# Alexander Graham Bell Elementary School

PUD Resubmittal 2 - Responses to Permit Review Comments
**DLR Group Project No. 73-10122-00**

**AG BELL ELEMENTARY SCHOOL PROJECT**
**PUD COMMENTS 2ND REVIEW – Revised**
**APRIL 20, 2011**

A1.4

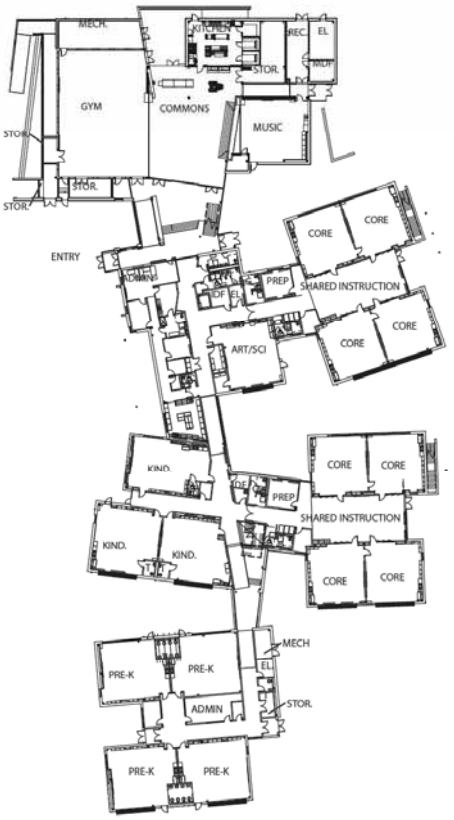
Please provide a scale for the proposed floor plans.

***RESPONSE***: See revised sheet A1.4.

A1.5

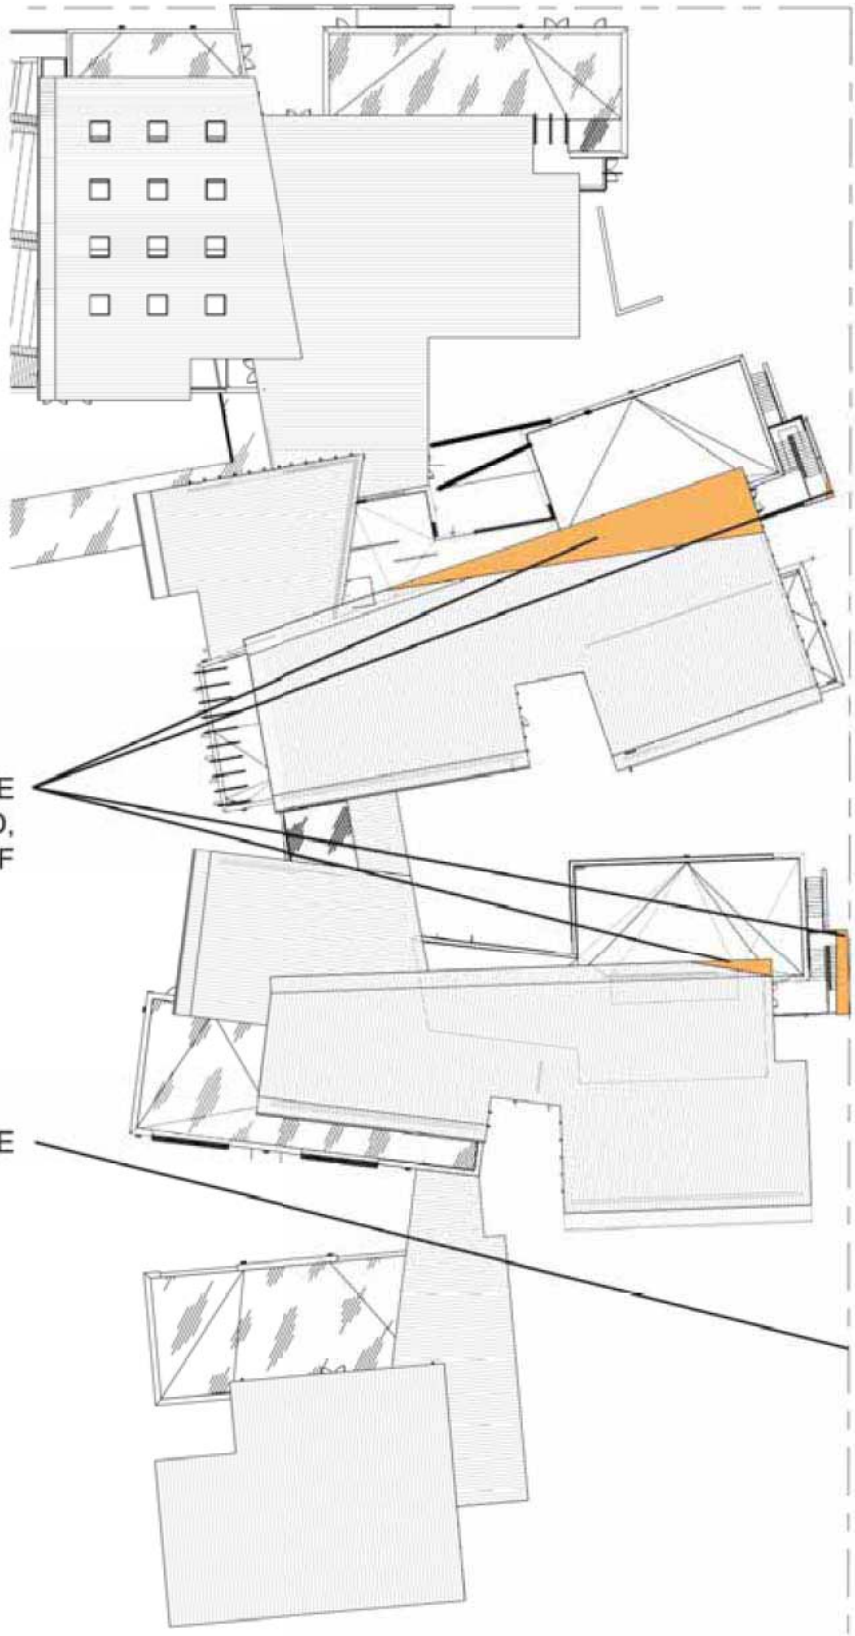
d. Please outline in plan view the roof area for which the variance is being requested. What is the total area of roof area in plan view for which the variance is being requested?

***RESPONSE***: The total area of roof for which the variance is being requested is approximately 1,800 sf. See attached page A1.5.

WEST ELEVATION A2.2

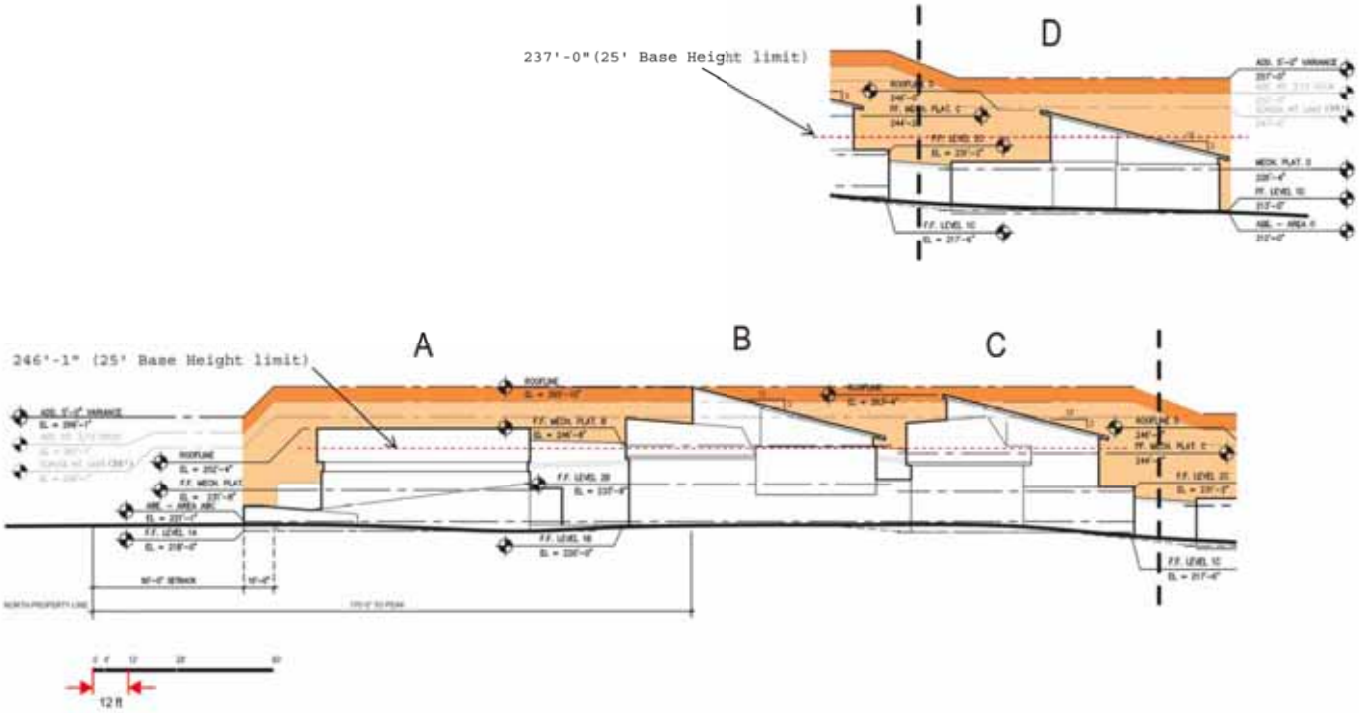
c. If the PUD for height is still needed, on PUD Resubmittal sheet A2.2 and A2.3 it appears that the maximum roofline elevation is 265′ – 10″. However, on the same sheets there is a statement *Add 5′-0″ Variance* at elevation 266′ -1″. Please confirm whether a 5′ variance or 4′-9″ variance is being requested as part of the PUD. The height needed should be requested.

a. In February 2011, staff requested that any view impacts be confirmed. Staff suggested a cross section drawing and/or photographs be submitted in order to review this item since a taller structure could potentially impact views from residential property located to the north and east. Given the potential small view impact, basic information regarding this topic may be provided. Staff suggests taking several photographs from the rooftop of the existing 'cafetorium' (since it is in the approximate locating of Proposed Building B) looking back towards the homes to the east and north in combination with elevation information to compare relative heights between properties and structures.

***RESPONSE***: A 5'-0" variance is being requested; this is approximately 3" in excess of the roof height indicated in the Design Documents. We feel that the added 3" is needed to account for construction tolerances.

***RESPONSE***: We recommend review of the cross sections on Sheet A2.2 and Sheet A2.3 to demonatrate how the zoning alowed heights contrast with the proposal. We have also included photos of the site from the residential properties to the east. It can be seen that existing vegetation and lowering of grade make views from those east properties unlikely to change with the proposed project. If this is inadequate, perhaps a walk-through could be conducted on site with staff, and those findings documented?

A5.1

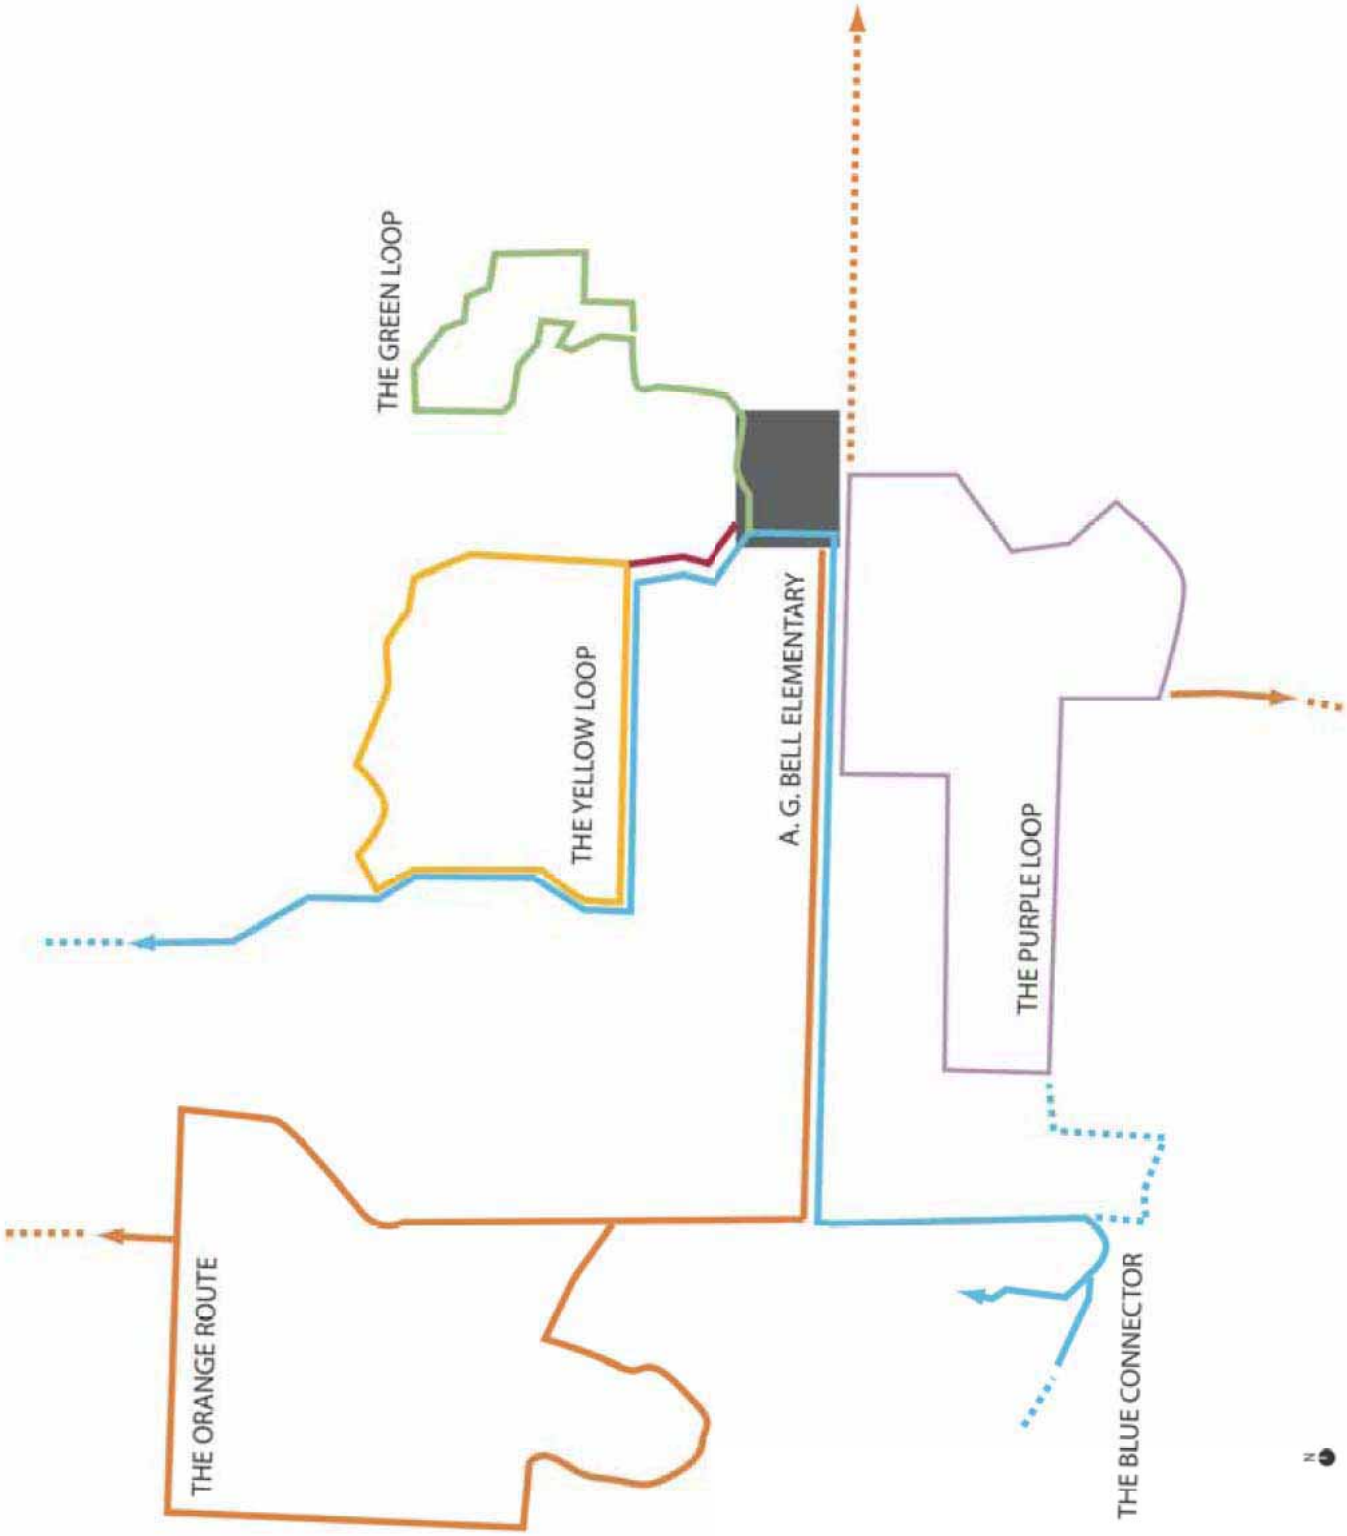
c) What is the source of the Loops identified on page A5.1 of the PUD Resubmittal? Are the Loops pedestrian school walk routes identified by the school district? Please provide some street name identifiers on the map.

***RESPONSE***: The walking routes shown on A5.1 are a duplication of the City of Kirkland Juanita Neighborhood Walking Loop map (see attached drawing A5.1a).

A5.2

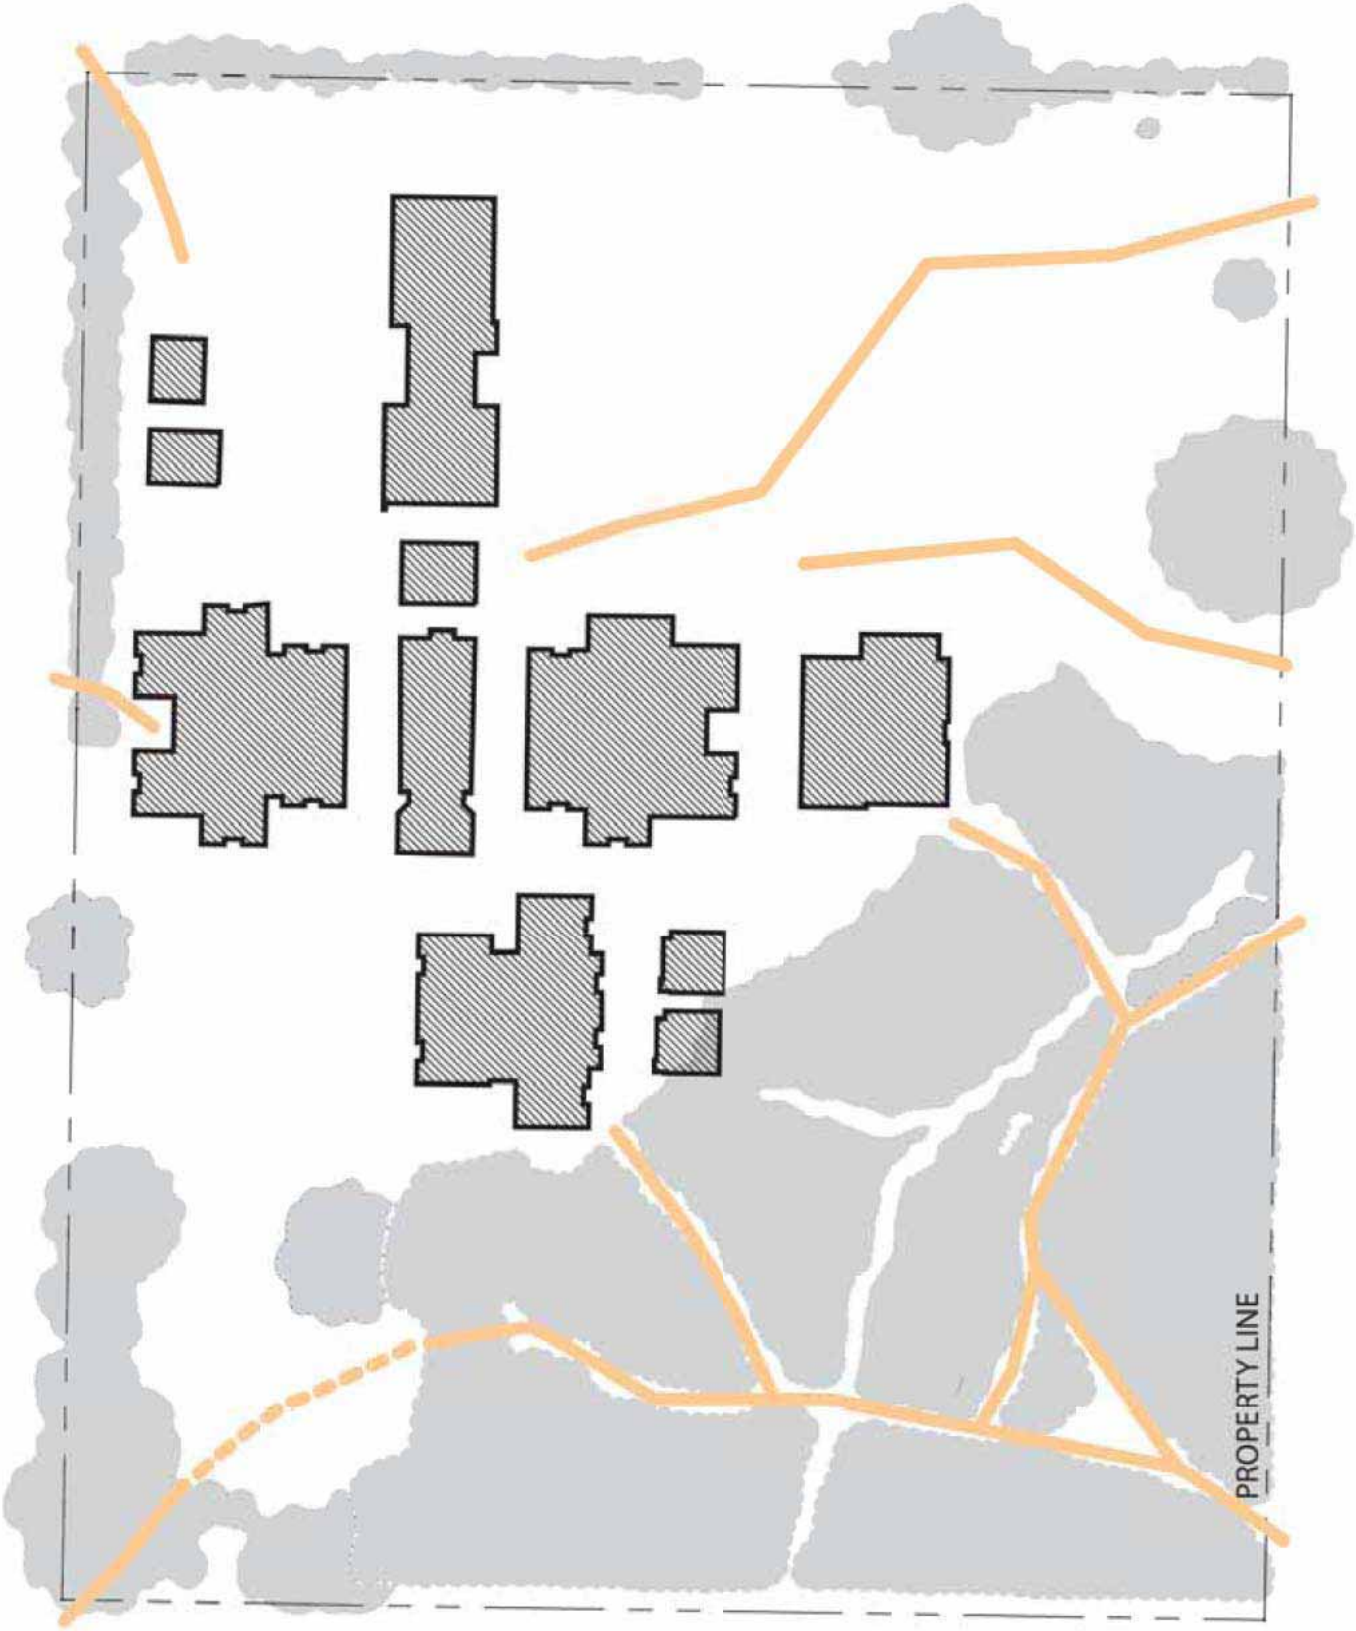
a) KZC 105.18 and KZC 105.19 contain provisions for pedestrian access. In the February 2011 comment letter, staff previously requested confirmation as to which pathways are above and beyond what KZC 105.18 & 105.19 requires. Since this is being contemplated as a public benefit, please provide additional information in regards to this topic. If the proposed pedestrian access cannot be shown to be above and beyond code requirements, then this item cannot be used as a PUD benefit.

***RESPONSE***: The drawings on pages A5.2 and A5.3 of the PUD re-submittal intend to indicate the improved pedestrian connections of the new AG Bell site scheme. KZC 105.18 states "Promoting an interconnected network of pedestrian routes within neighborhoods is an important goal within the City. Providing pedestrian access from buildings to abutting rights of way, walkways and other uses on the subject property, and connections between properties help meet the objectives of nonmotorized transportation policies." Our interpretation is that providing a single means of egress connecting the new AG Bell to the North neighborhood walkways and the South right of way (NE 112th St) would fulfill the general intent of this Zoning provision. The sidewalk immediately West of the new building, for example, satisfies this requirement. Sidewalks at the Frontage and within parking lots also fulfill the basic requirements of KZC 105.18 and 105.19. We feel that the (2) sidewalks in the East/West direction are above and beyond the basic code requirements as they help strengthen the connection between AG Bell and the existing Juanita Neighborhood walking loops. Additionally, while the pathway directly from the Northeast corner of the site to the building entry may qualify as a required walkway connection, the continuation of this along the East side of the building down to NE 112th St is a superior benefit. See new page A5.3a for our interpretation of minimal sidewalks to meet the intent of the Zoning Code.

A6.2

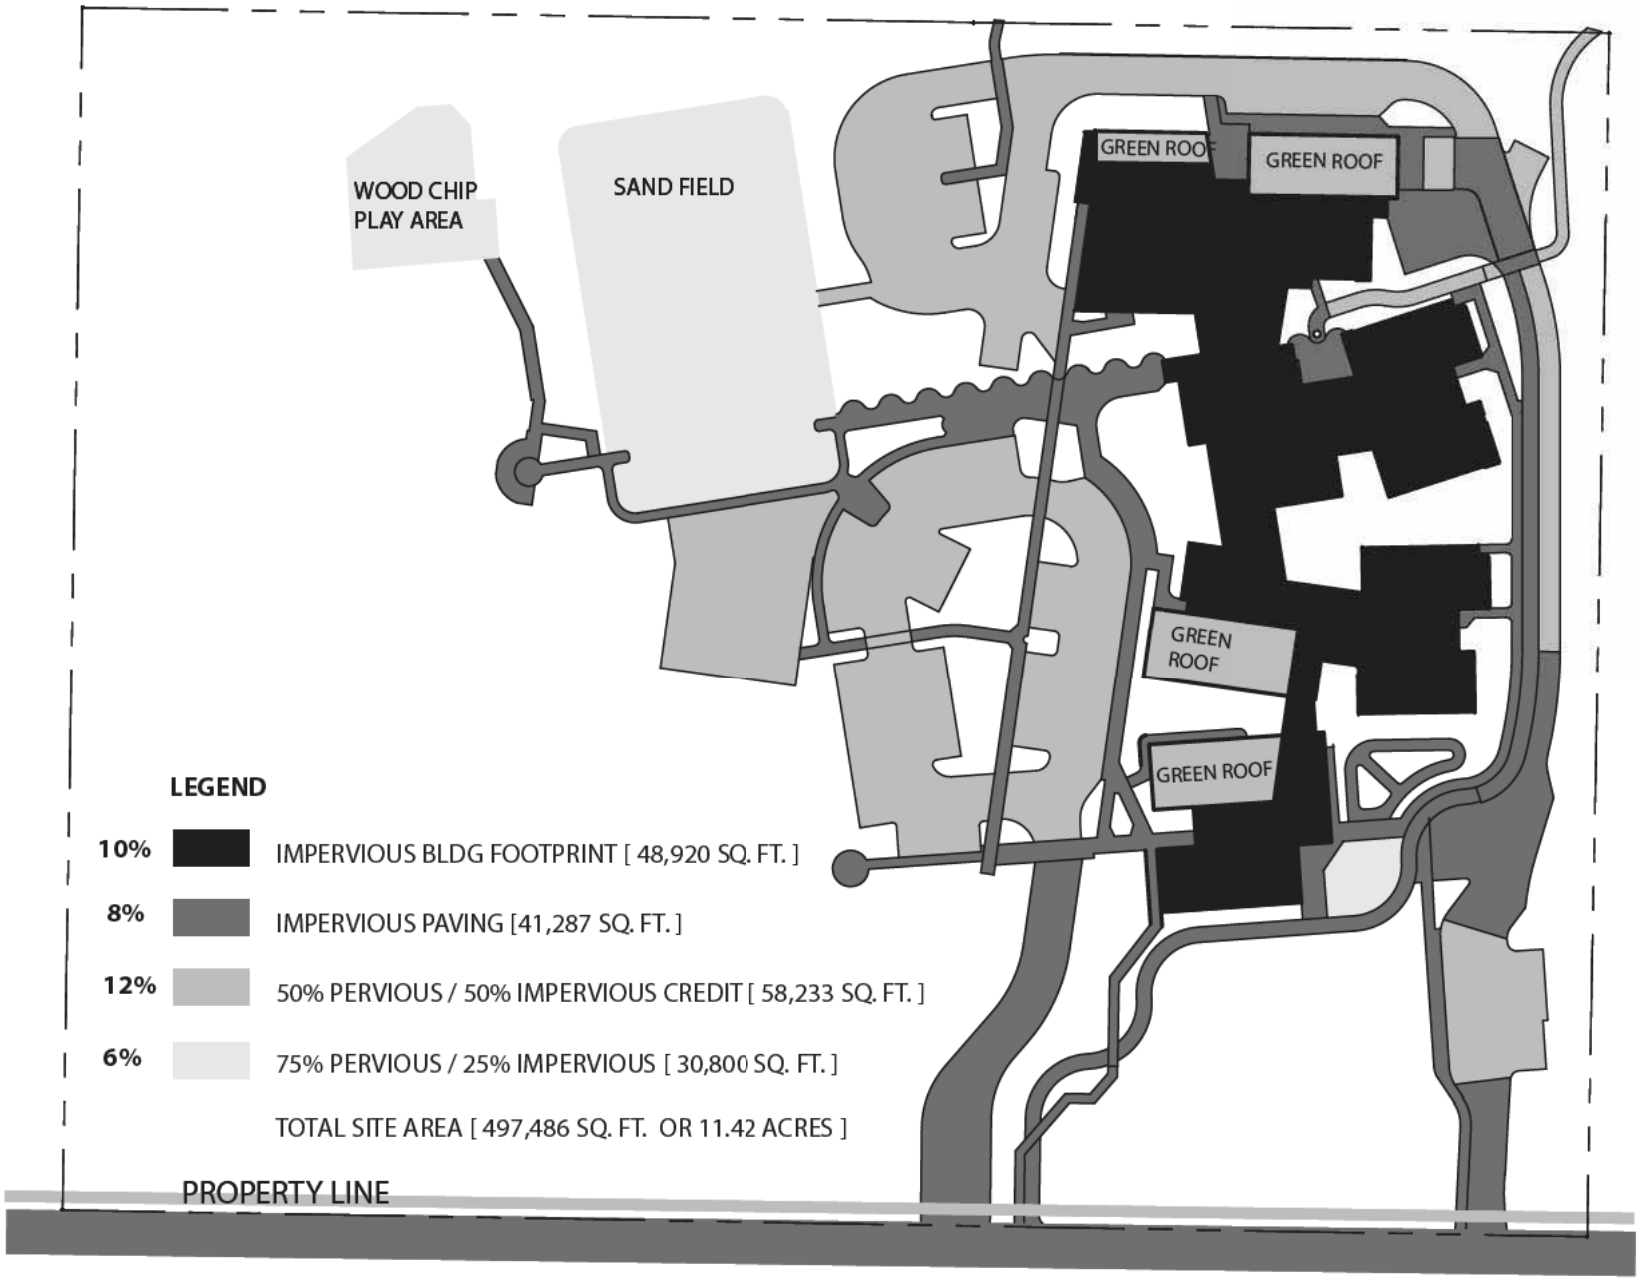
The drawing on page A6.2 shows green roofs included as part of the pervious area calculation. Please confirm if green roofs are being constructed with this project. Also, the current code does not allow green roofs to be calculated at a 50% ratio when determining zoning lot coverage maximums. Please verify with Public Works as to how green roofs relate to their storm water requirements.

***RESPONSE***: Green roofs are part of the project and occur where indicated on Sheet A6.2. See revised Lot Coverage calculation on Sheet A6.2a.
